URBAN DESIGN COMMISSION APPLICATION

Address: 6509 Normandy Lane, Madison, WI 53719
Title: Normandy Square Senior Apartments

RE: 6509 Normandy Lane - 3 Story Mixed Use
Final Approval Submittal

TITLE: 6509 Normandy Lane – Three-Story
Apartment Building Containing 57 Units
and 2,287 Square Feet of First Floor
Commercial Space. 19th Ald. Dist. (44355)

SITE PLAN C1.0

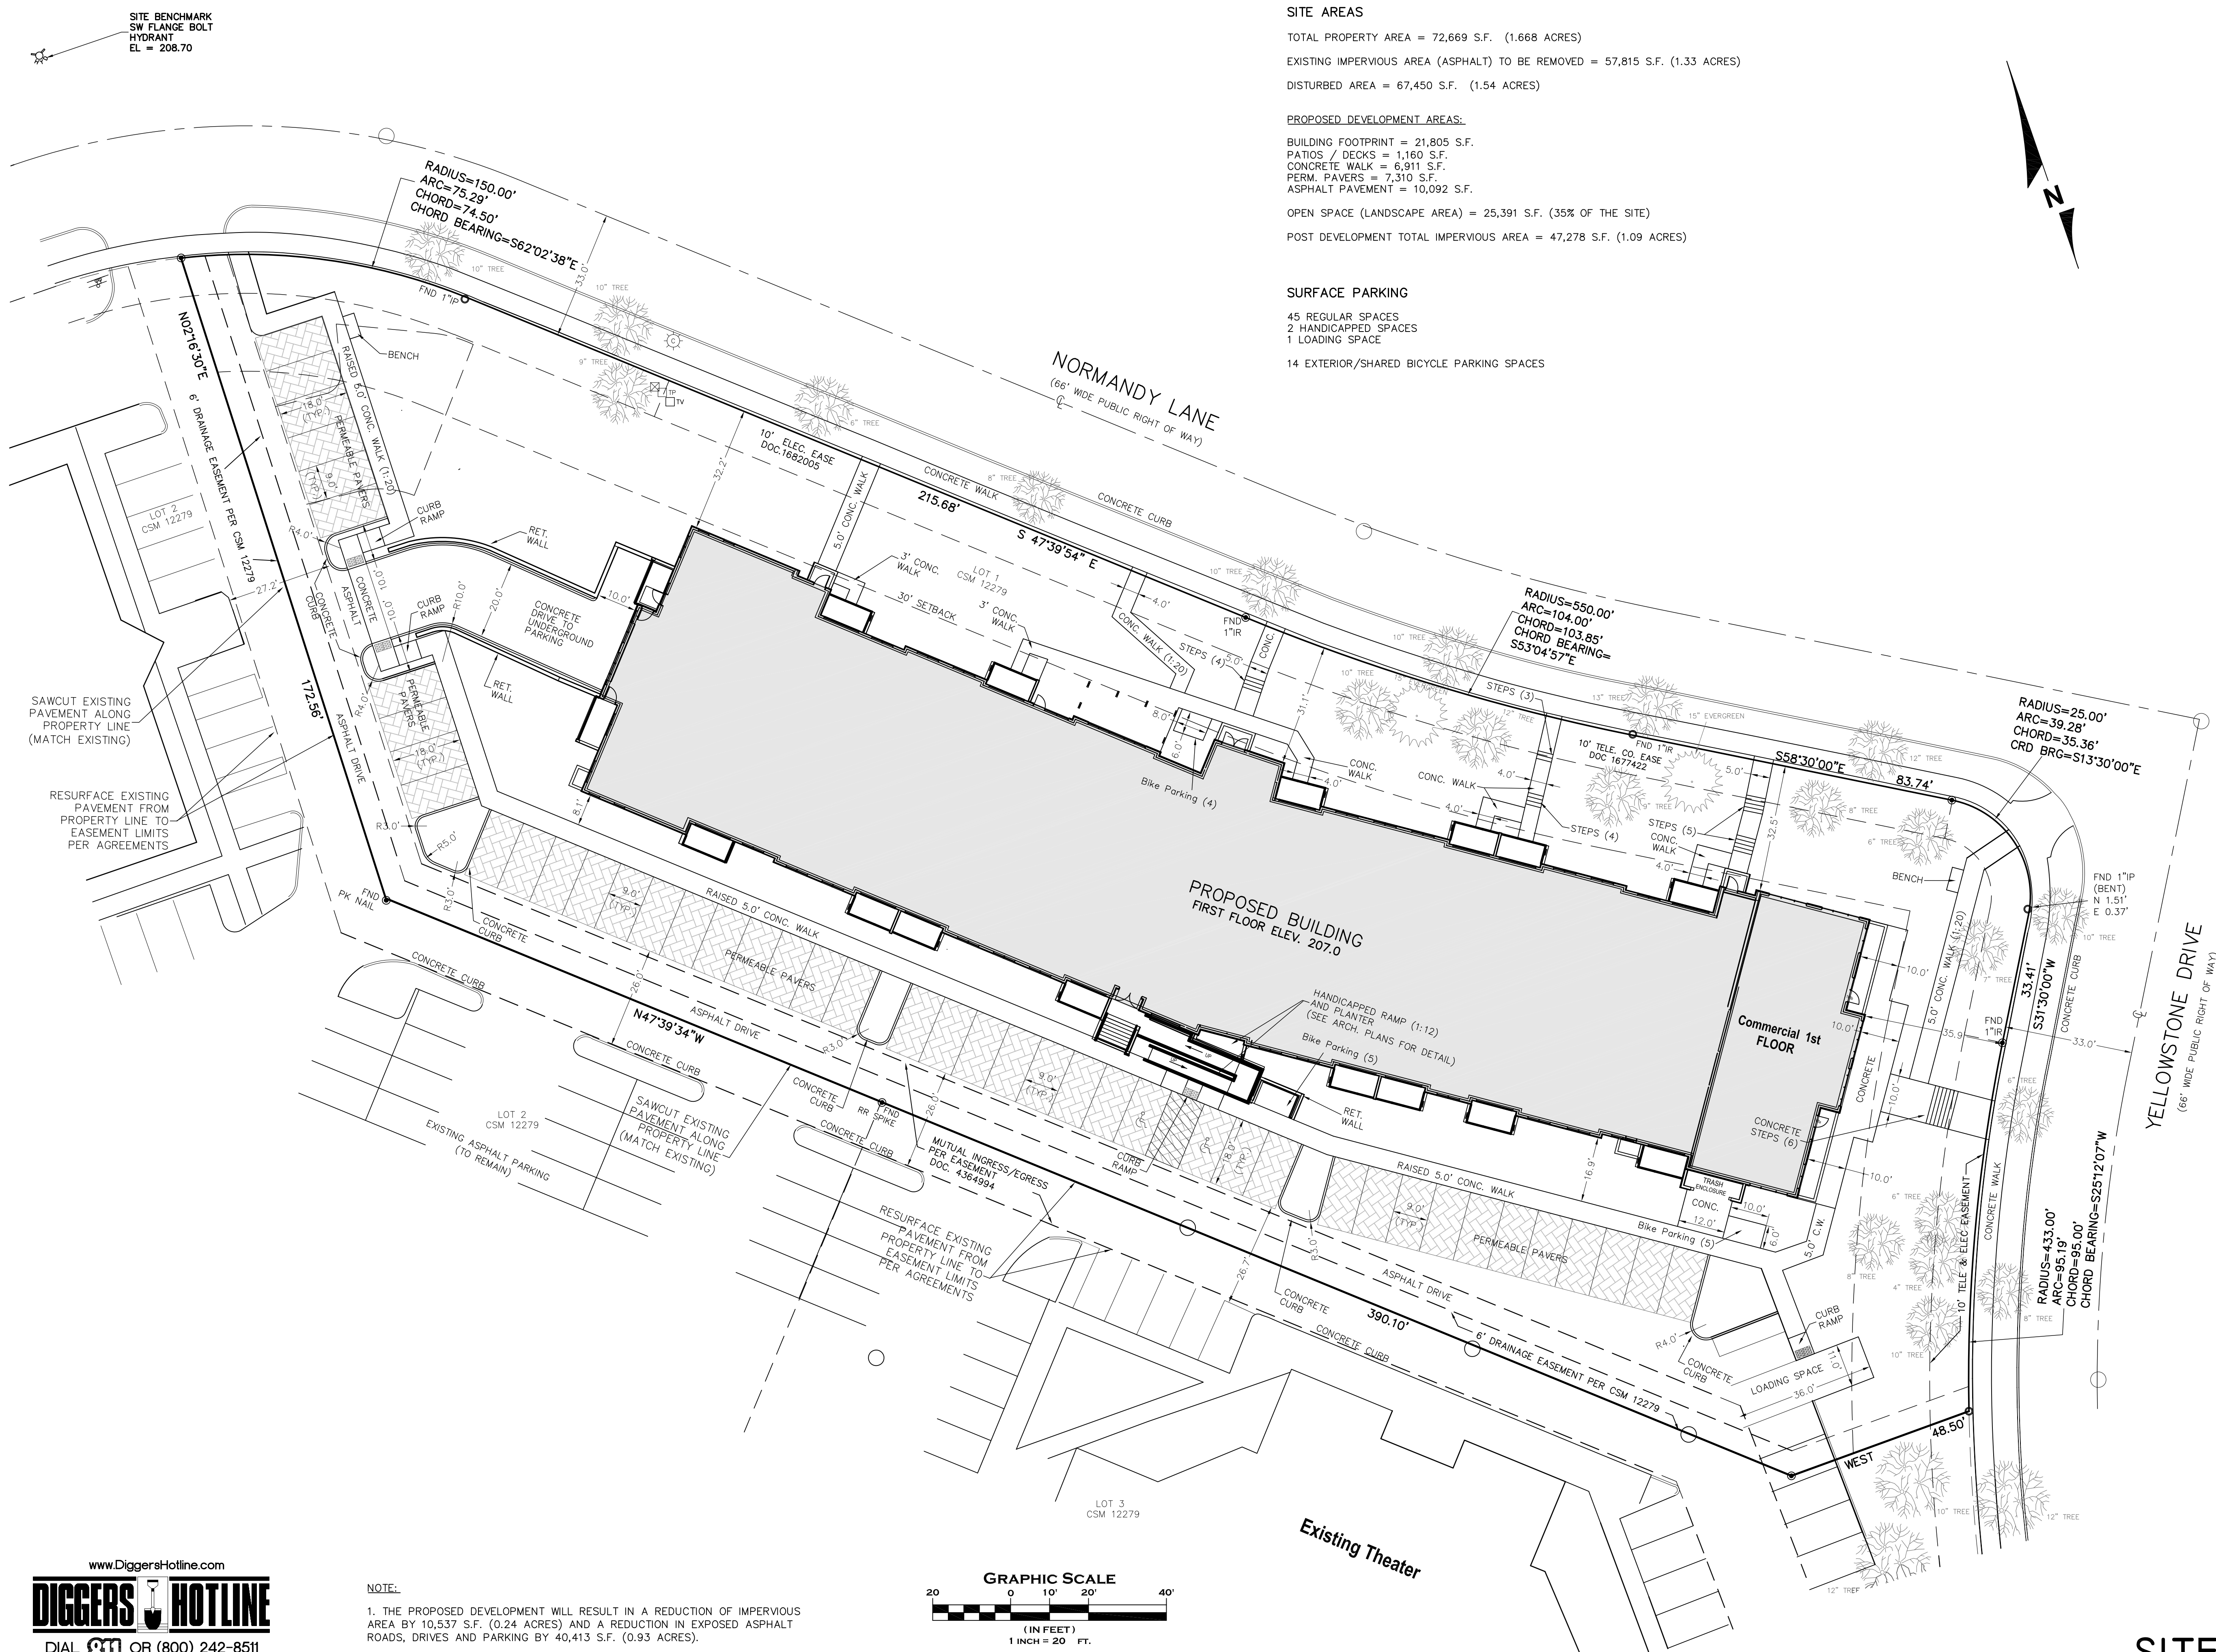
- Add trees to the southerly parking stalls and in open spaces at the west drive along Normandy Lane.
Tree islands and trees were added to the south and west parking lot to break up the parking area and provide shade.

- Enlarge the front patio to at least 14 feet in width.
The patio area was enlarged to 24.3 feet in width.
- Recommend that gray projecting bay above the main north elevation entry doesn't pop up to be consistent with other gray projecting rooflines.
The North entrances have been revised to provide a stronger identity. It has been redesigned to have a sloped roof and overhang that highlights the entrance. The large glass windows on the upper level activity rooms rest on a masonry base at the front door.
